Objection to planning application 2020/2612/P, registered 30.07.2020

Spectrum House, 32-24 Gordon House Road

Installation of 34x A/C condenser units on the east and west elevations and on the ground floor and roof level.

27.08.2020

Photo 3: Acoustic ratings

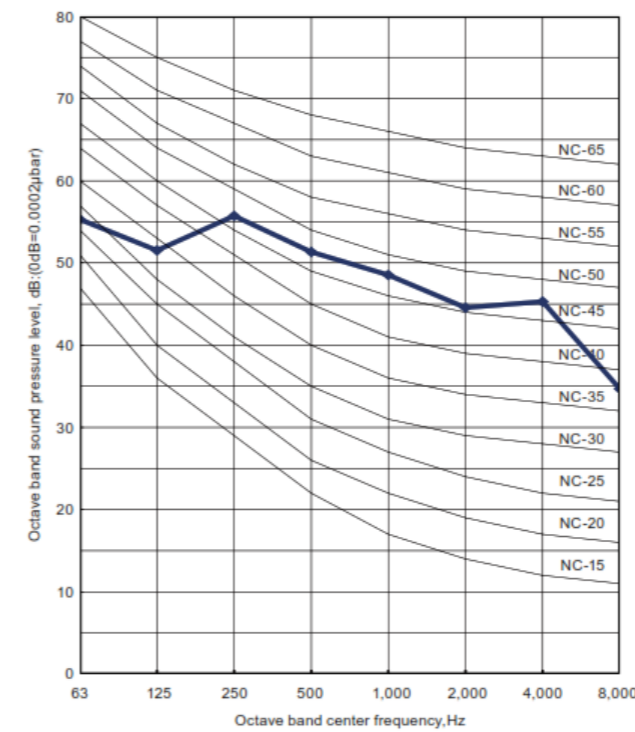
- f. This was the unit installed in early 2020, from which time noise conditions in Clanfield became much worse.
- g. Additionally, the Fujitsu unit in Location 7 is of a different (approx. 50% larger) model than the others along the NE wall (see Photo 2 in appendix). It is listed as a “DC Inverter”, although it is in fact an “Inverter”, seemingly model type AO*G30LFT. This model is more powerful and is significantly noisier. The correct model type should be identified along with it’s acoustic properties (see Photo 3 for what I believe to be the acoustic curves for this model).

Photo 2: 2 large FCU's at Location 7
Both incorrectly identified on Inventory, 26.08.2020

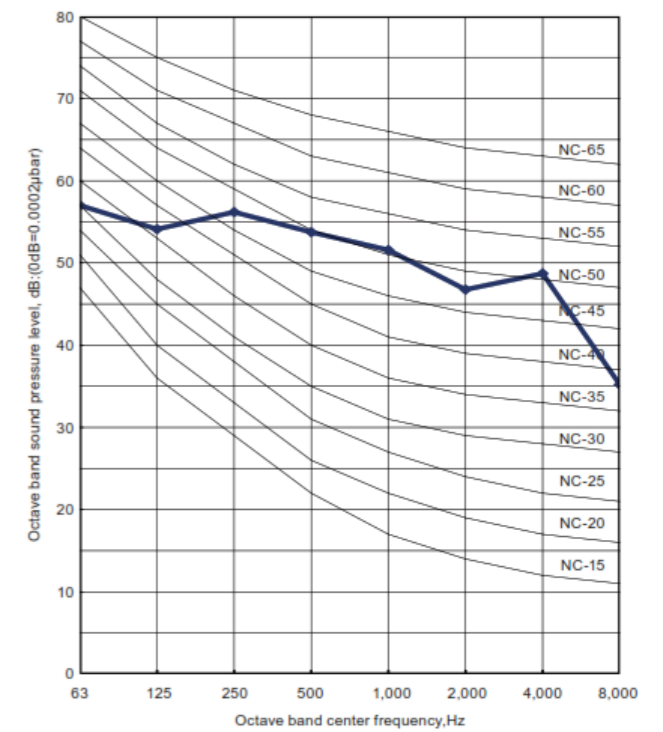
- f. The front bedroom experiences some background noise issues at night, in addition to some car noise from Gordon House Road.
- g. There have not always been two FCU's in location 7 – I took aerial photographs in May 2018 which show only one FCU in location 7, nearest my rear bedroom.

Photo 4: ID label
Unit incorrectly identified on Inventory

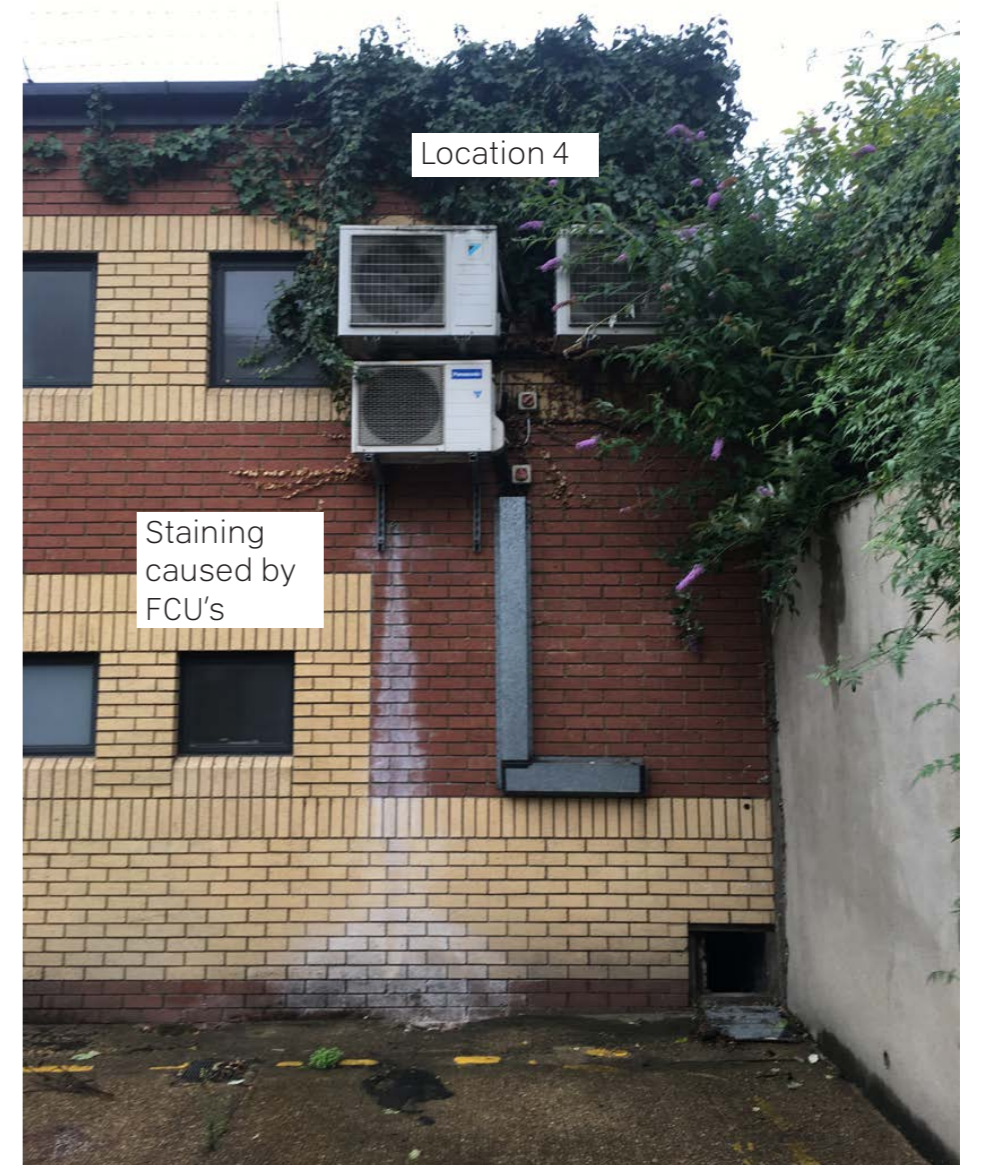
- e. Table 2.1 also contains an error of the Daikin FCU type closest to Clanfield – one of the ones noted in the Inventory as NE Elevation(S). In fact this FCU is the type “AZAS100M7V1B” (manufactured 08.2019) as identified on the unit’s ID badge (see Photo 4 in appendix). This model has a far greater acoustic output (especially at lower sound frequencies) – one of the highest of all the units installed on Spectrum House – compared with the model incorrectly assigned in the Inventory (RZASG71MV1).

Photo 5

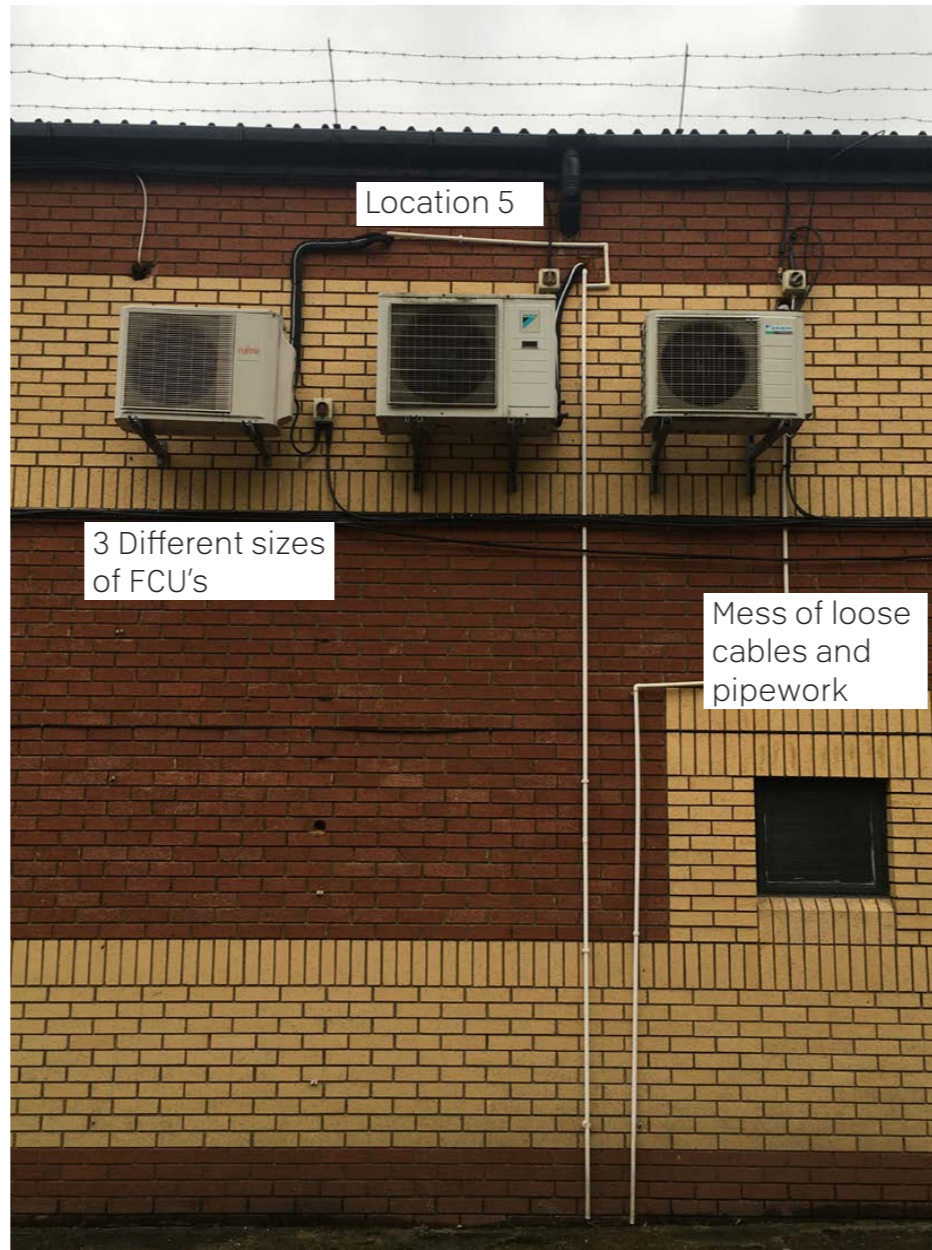
- a. The appearance of the overall FCU's installation on the NE wall is chaotic, ugly, and totally ill-considered, as demonstrated in the photos in the Appendix. A range of different size units are mounted at different heights to the cheapest possible mounting framework. Cables are poorly fixed to the building (not in trunking); white plastic condensate pipes trail down to the floor.
- b. Redundant mounting brackets, trunking, cabling, pipework and switches are left in place.

Location 6: Ugly installation of FCUs etc.

Photo 6

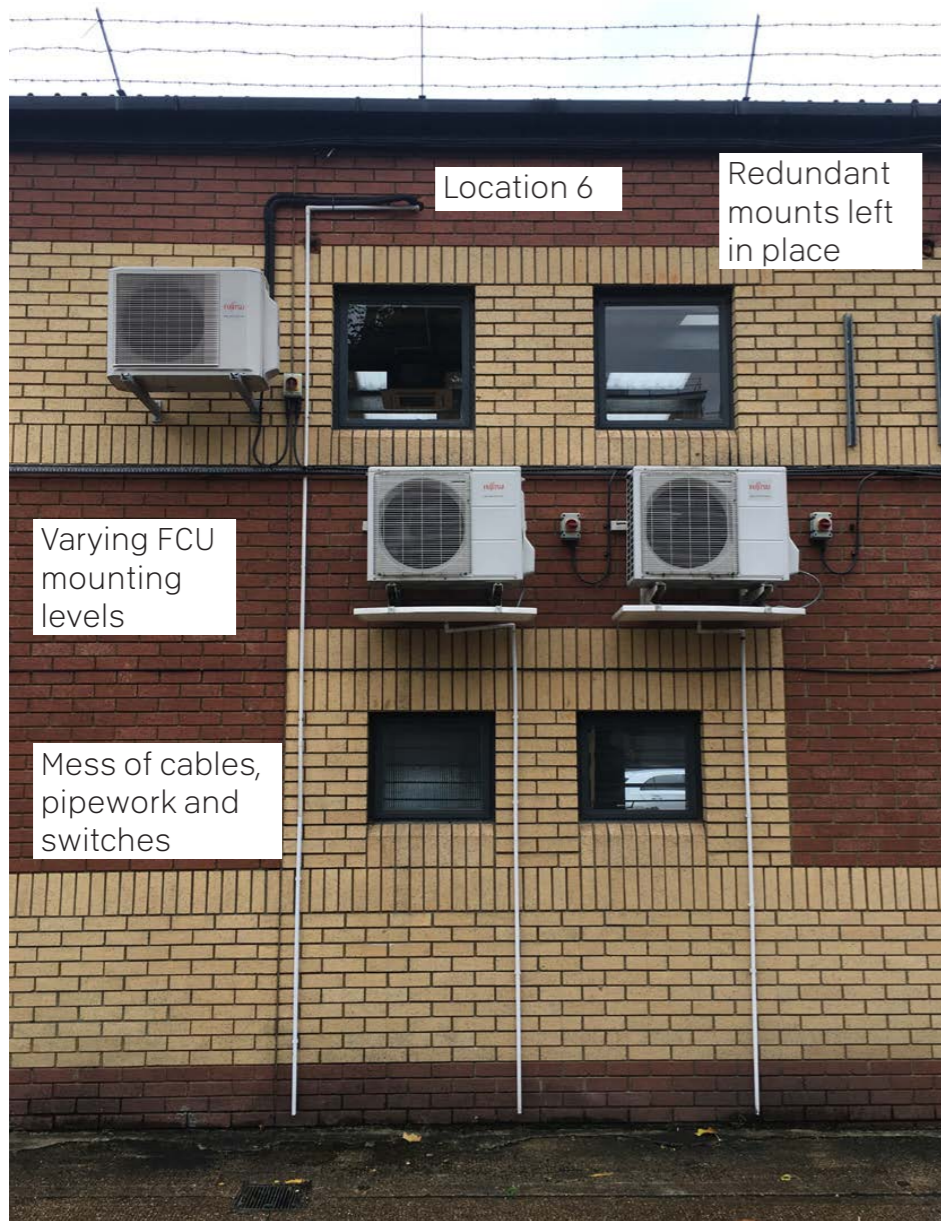
Location 5: Ugly installation

Time History Graph A1

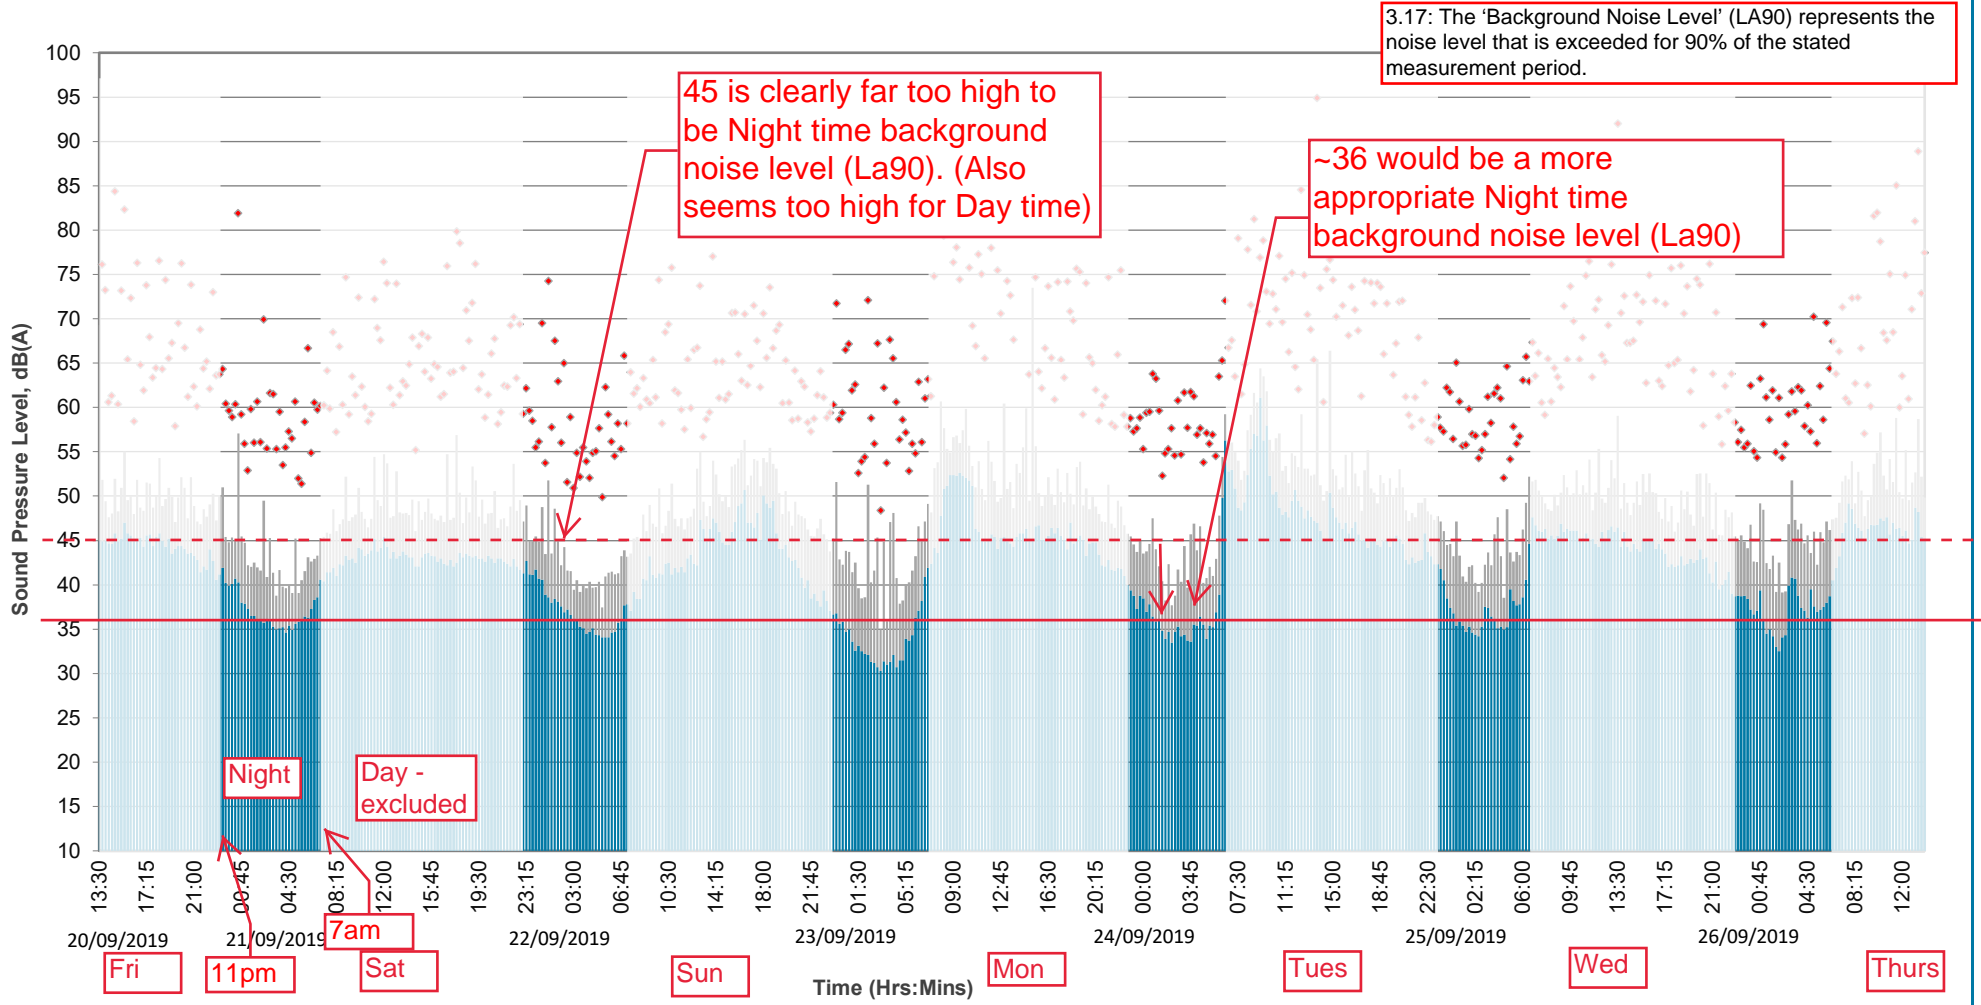
- e. Night time background noise values, from the graphs, would seem to be suitably at around 36dB (A1) and 42dB (A2) – see markups in Appendix. These values are hugely less than the used "Daytime" values (-9dB, and -10dB) – though as noted above are anyway in serious question because of the unsuitability of locations A1 and A2. For the current report, these would result in target values according to the Camden criteria of 27dB and 33dB (subtracting 10dB).

Night time background noise study (A1)

Time History Graph A2

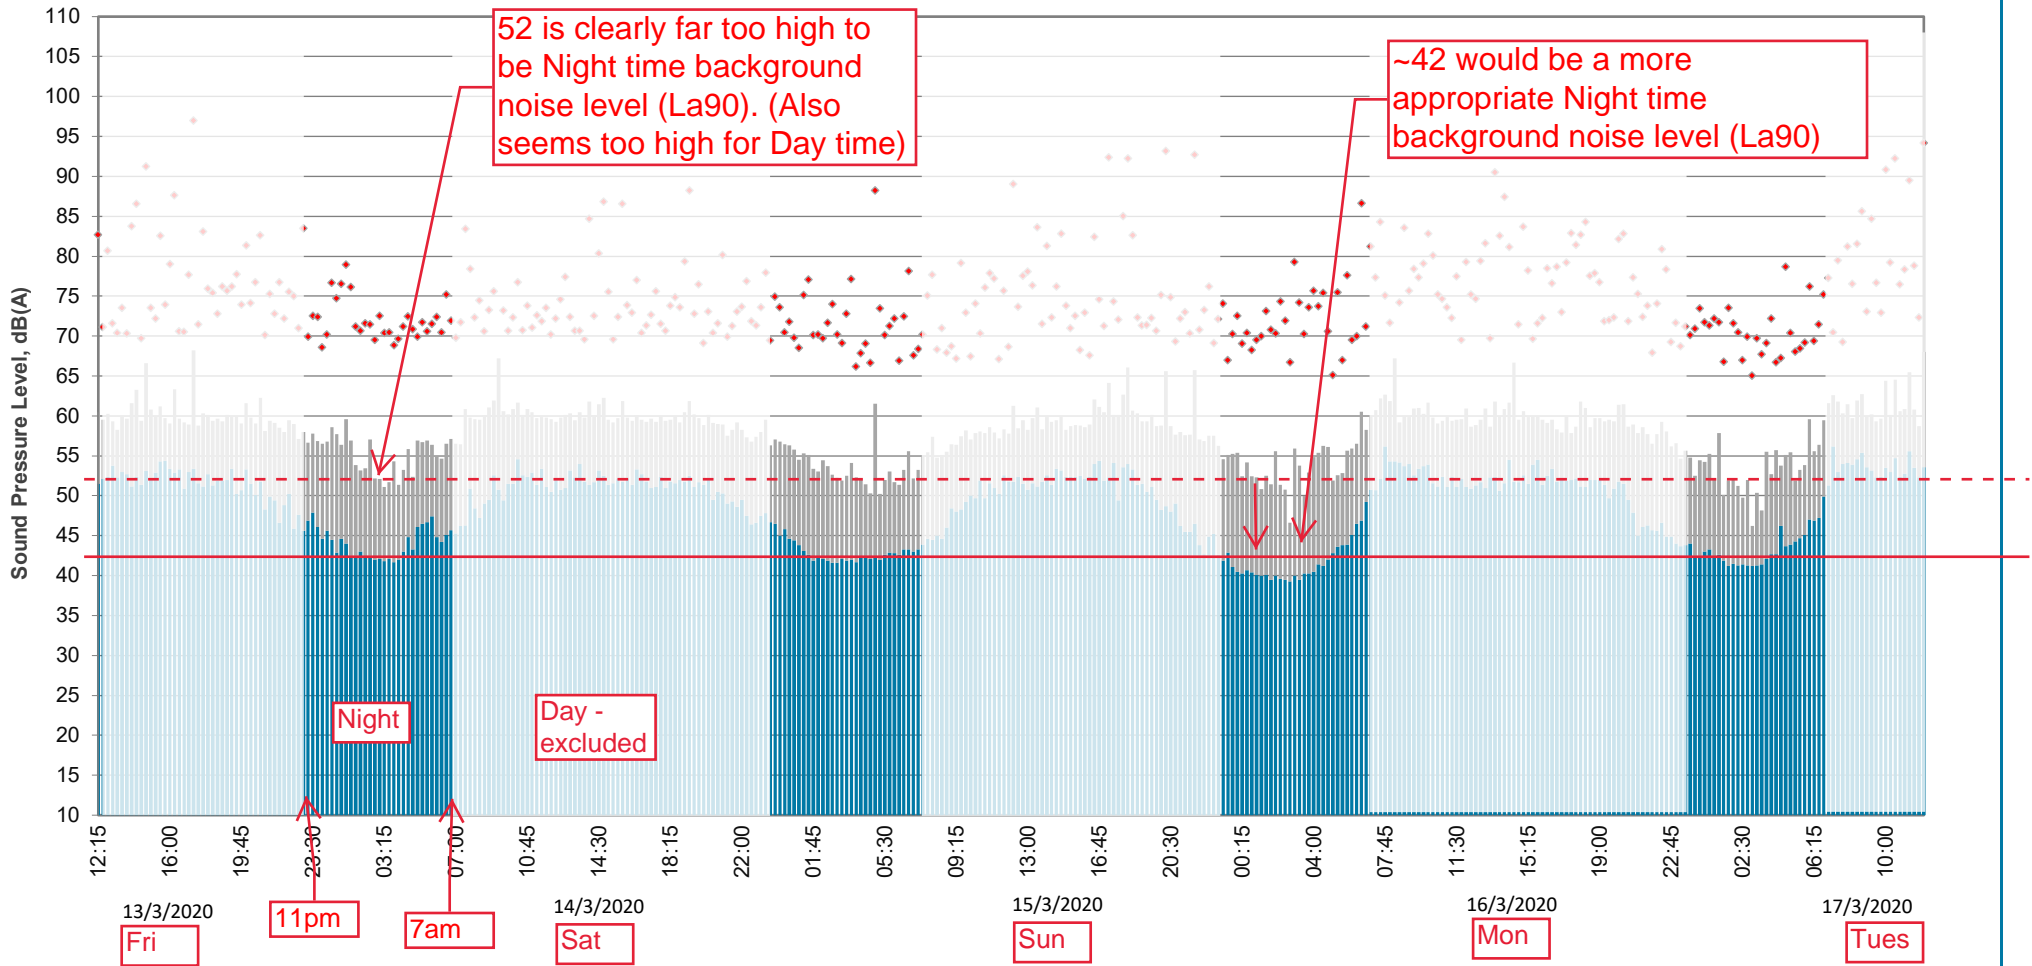
Night time background noise study (A2)
